Upper Barataria Basin, Louisiana, Feasibility Study

Appendix G – Public Comments and Responses

USACE Responses to Public Comments on 2nd Draft Report

Option #1

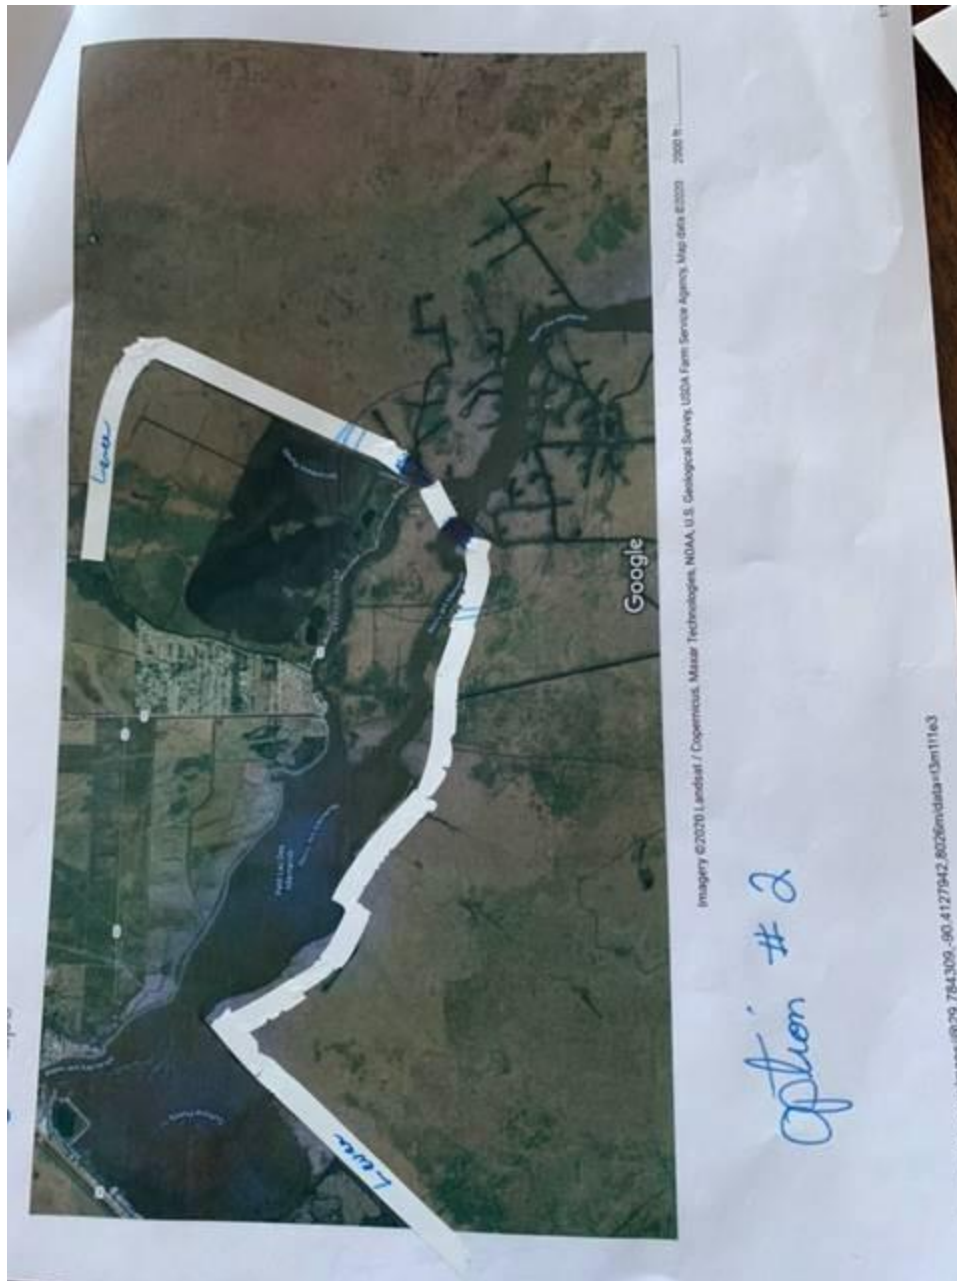
We very much appreciate you and the St. Charles Parish team reaching out to the affected residents and seeking our input and hearing our concerns. We do have questions we'd like answered when known. We wholeheartedly support constructing a levee system in the marsh, as Mr. Chiasson has depicted as Option 2 which is attached. This Option will protect ALL Bayou Gauche residents and leaves no one unprotected from storm surge. There's only one shot at this, so let's do the right thing and protect all residents. There are hundreds of miles of levees presently in the marsh including this project. If for some reason this can't be done, we'd want to see the levee follow the north side of Hwy. 306 towards Sunset Drainage Canal, following canal south beyond the pump station and connecting to existing levee at this point (Mr. Chiasson Option 1 attached.) This option offers much less impacts to all affected residents.

We encourage you to take serious consideration to Mr. Chiasson's options to construct within the marsh and protect all residents or along Hwy. 306 and maintain a safe distance from Kerry's Pointe homes.
